Centennial Coal

Response to Submissions

Newstan Colliery

Subsidence Management Plan

Figure 1 - Fassifern Seam longwalls below Haul Road

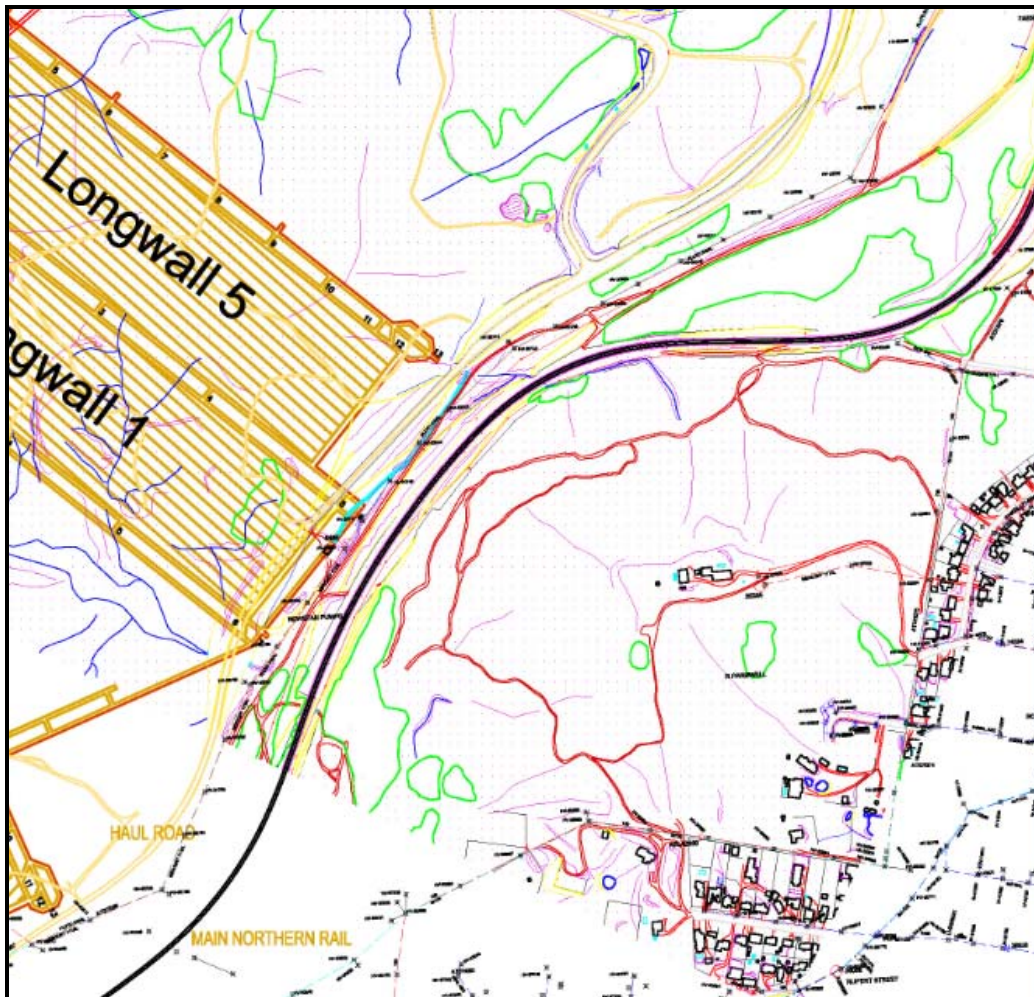
There is no history of longwall mining under the haul road as such there is concern over Centennial Newstan being able to maintain safe, serviceable and repairable criteria. Up to 1200 millimetres of subsidence is predicted above longwalls 101-103 and it is difficult to believe that it is possible to maintain safe and serviceable conditions using normal road maintenance conditions.

Centennial Newstan (at that stage Elcom) has previously undermined the haul road in the Fassifern seam. The depth of cover was between 40 metres and 50 metres, the extraction height was 2.96 metres and the longwall width was 206.3 metres. These factors would have contributed to an increased subsidence profile when compared to the current mine design, which has a significantly higher depth of cover (210 m to 350 m) and a slightly lower average extraction height (2.7 metres) in the SMP Study Area.

The previous mining in the Fassifern Seam is not superimposed with the proposed mine workings, thus precluding the possibility of compound subsidence effects. The extent of the undermining can be seen in Figure 1, shown below, with the haul road crossing longwall 1.
